Pilot Region-Based Optimization Program for Fund-Lead Sites in EPA Region 3

Site Optimization Tracker: Raymark Hatboro, Pennsylvania

EPA 542-R-06-006f
December 2006
www.epa.gov

Report of the Remediation System Evaluation,
Site Visit Conducted at the Raymark Superfund Site
June 7-8, 2001

FIGURE 1-3. CROSS SECTION OF THE GEOLOGY UNDERLYING THE RAYMARK SITE.

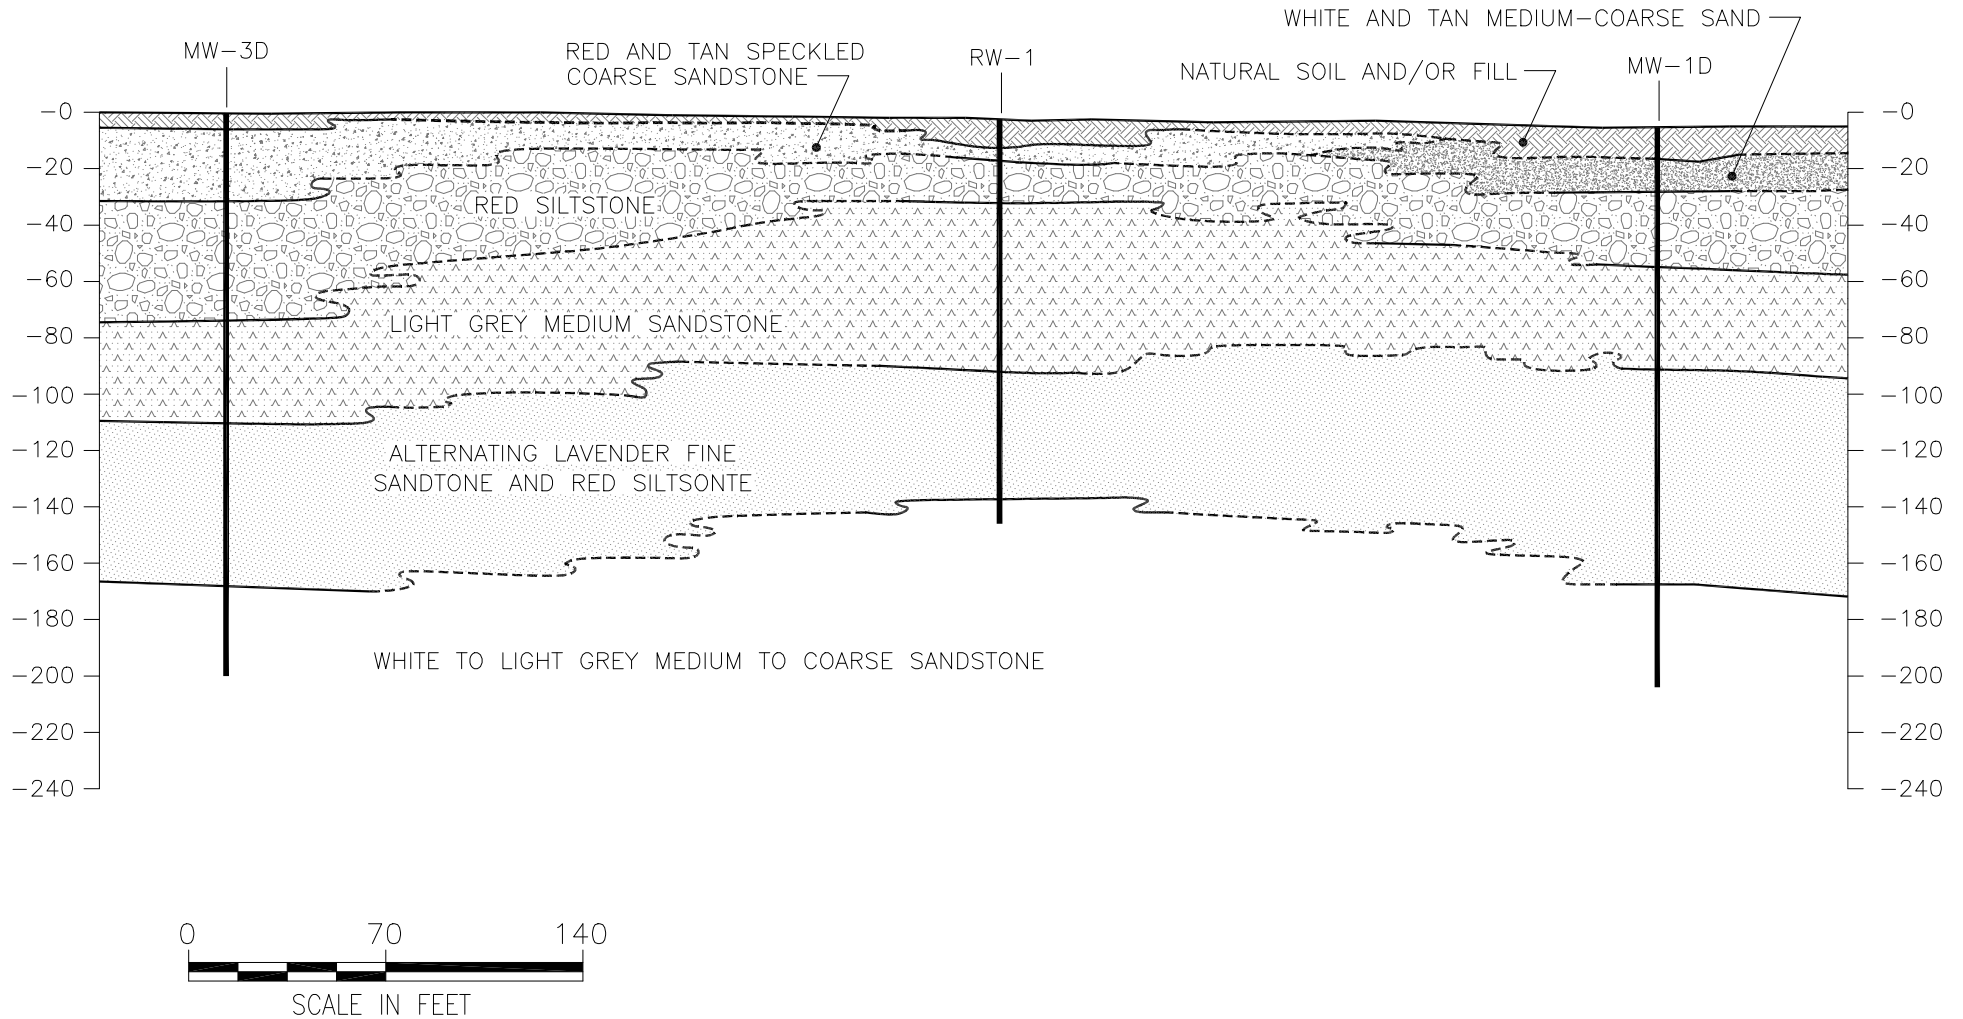
The extent of ground water TCE contamination onsite should be further investigated as well, especially along the site boundaries. A cluster of sampling points each independently screening the stratigraphic units shown in Figure 1-3 and located midway between the MW-3 and MW-2 clusters would help delineate the plume on the western boundary of the site. This is significant given that ground water likely flows to the west toward Pennypack Creek and Hatboro wells H-14 and H-17. Another cluster of sampling points each screening the stratigraphic units shown in Figure 1-3 and located midway between the MW-3 cluster and the rear end of the property (to the east) would help delineate the plume on the southern/western site boundary. This is also significant because Pennypack Creek turns and passes within a mile to the southwest of the site and ground water could be flowing in that direction. These points should be added to the annual sampling program and analyzed for volatile organic compounds (VOCs).
